ASSESSMENT REPORT

DEVELOPMENT APPLICATION (REVISED) (2016STH035 – DA10.2016.304.1)

PROPOSED MIXED USE DEVELOPMENT RETAIL & COMMERCIAL PREMISES AND SHOP-TOP HOUSING

Various Allotments
Terralong, Akuna and Shoalhaven Streets
Kiama

Figure 2: Building Height Plane for Original Proposal.
(ADM Architects Drawing A701-D dated October 2017)

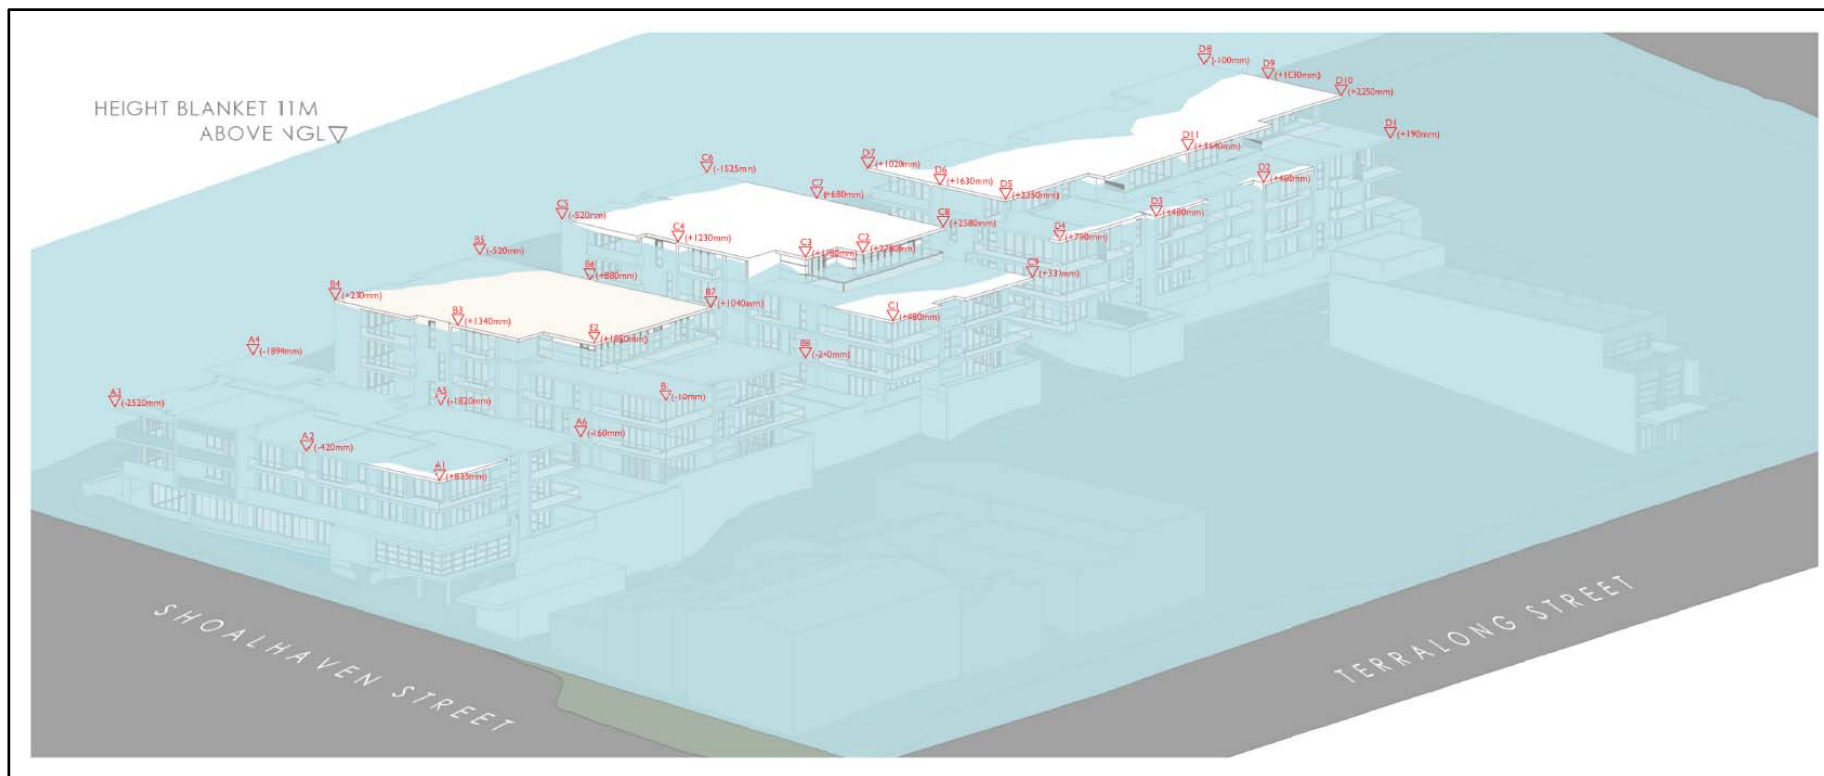
The development proposal the subject of my previous Assessment comprised a maximum building height of the development of 13.78 m (**Figure 2**).

As is evident from **Figure 2** below, each of the buildings associated with this earlier proposal encroached the building height limit to some degree, in some instances only to a minor degree, but in other cases to a more significant degree.

This previous proposal generally complied with the 11 m building height limit along the Akuna Street frontage of the site (except from a minor encroachment at the south-eastern corner of Building B of 230 mm and Building D 1020 mm); however, the upper floor level of the development still encroached for each of the blocks as follows:

- Block A – 835 mm (north-eastern corner);
- Block B – 1040 mm to 1850 mm along the northern edge of roof
- Block C – 2580 mm to 2780 mm along the northern edge of roof
- Block D & E – between 2250 mm and 2350 mm (along northern edge of roof).

Figure 3: Building Height Plane for the Revised Proposal
(ADM Architects Drawing A701-X dated February 2018)

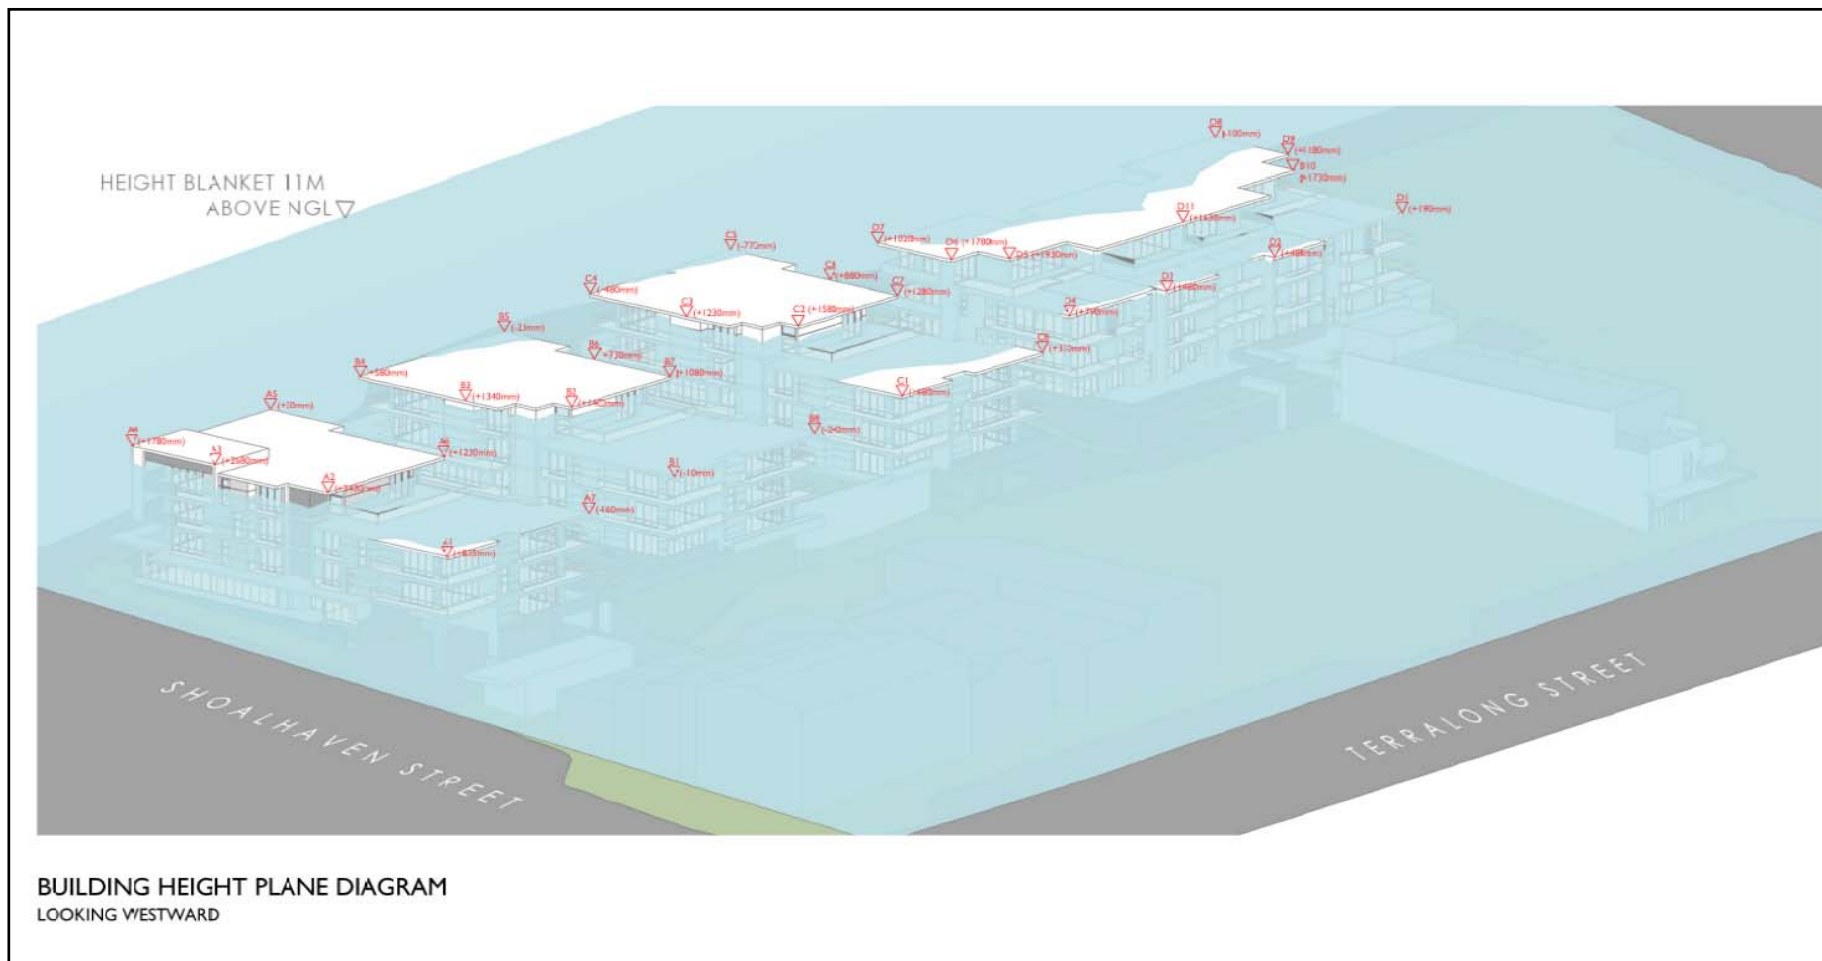
The revised proposal will have a maximum height above ground level of 13.68 m for Building A along the Shoalhaven Street frontage of the site (**Figure 3**)

This revised proposal also generally complies with the 11 m building height limit along the Akuna Street frontage of the site with the exception of encroachments at the south-eastern corners of; Building B of 580 mm, Building C of 480 mm and Building D of 1020 mm. On the face, it would appear the extent of encroachment along the Akuna Street frontage of the development has increased, however it should be noted that the retention of the significant trees along the Akuna Street frontage of the site, Buildings A, B and C has been set back further from the Akuna Street frontage of the site to the previous original proposal. The existing ground levels at these points is lower when compared to the original Akuna Street façade of the original development. As a result, whilst the overall extent of building height encroachments for Buildings B, C and D & E have been reduced, there is an apparent increase in height encroachment along the Akuna Street frontage. In reality the height of the development when viewed from Akuna Street has however not changed from the original Proposal.

The exception to the above is Building A. The height of Building A has been increased in the revised proposal with the addition of an additional floor level containing three residential units. This additional floor level is now proposed following advice from Council's Architectural and Urban Design consultant (BHI Architects). As will be discussed in Section 5.6.1 below, BHI have taken the view that the Akuna and Shoalhaven Street corner of the development should be articulated with built form emphasis through an additional storey of apartments at the corner and a stepped awning to match Buildings B and C. As a result, Building A encroaches the 11 m building height limit along its Akuna Street frontage by 1780 mm at the corner, although this encroachment reduces to 30 mm at the western corner of this building.

Figure 5: Photomontage A (view from Terralong Street).

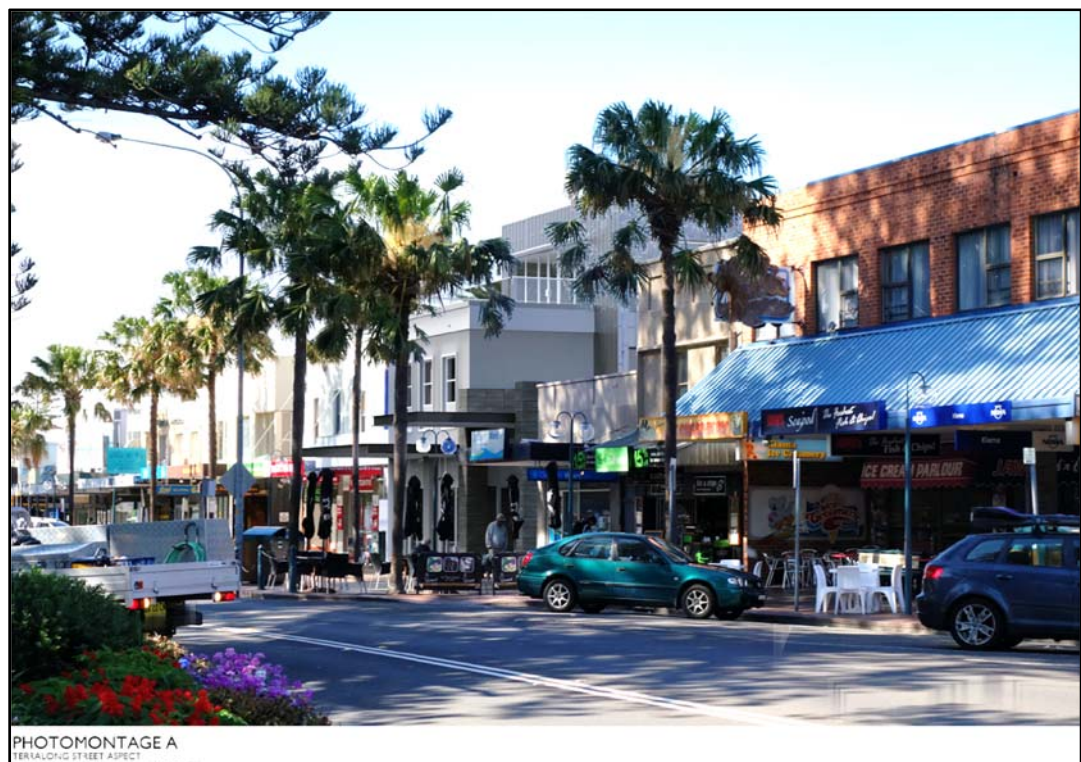
Figure 5 depicts a view of the proposed commercial development when viewed from Terralong Street. This part of the development complies with the 11 metre building height limit that applies to the site. Whilst this part of the development is 3 storeys in height, and adjoining developments are primarily 2 storey height, the setting back of the upper level of the revised proposal assists with reducing the visual bulk and scale of the development to an extent that this part of the proposal is considered to satisfactorily fit within the Terralong streetscape.

Figure 11: Photomontage G (view of revised proposal from within Hindmarsh Park).

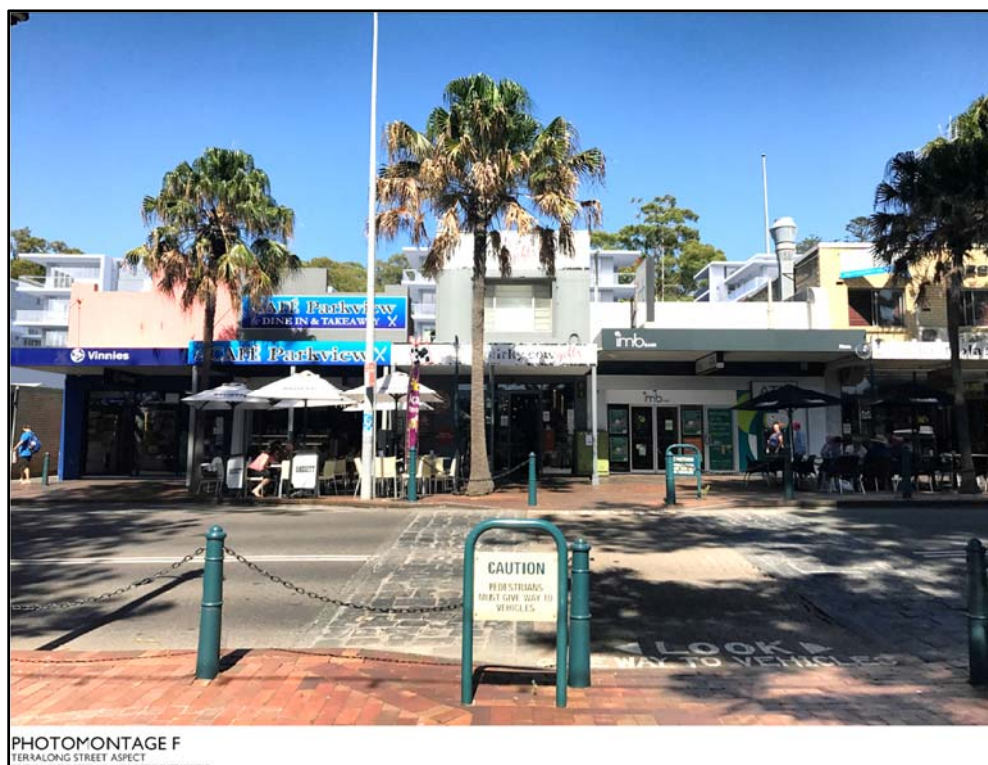
Figure 11 provides a depiction of the view of the development when viewed from a position within Hindmarsh Park. From this location the revised proposal will not be as shielded by existing development along Terralong Street and will be more pronounced, when compared to views taken from along Terralong Street. However again the development will still be stepped back from Terralong Street, and due to the mature trees that are located along Terralong Street and within the park itself, the visual prominence of the revised proposal will be largely screened from view from within Hindmarsh Park as is evident from this photomontage. It should be noted that this photomontage has been taken from a position where the view of the development site will be more open compared to other possible vantage points within the park, where the mature trees along Terralong Street will largely screen the development from view.
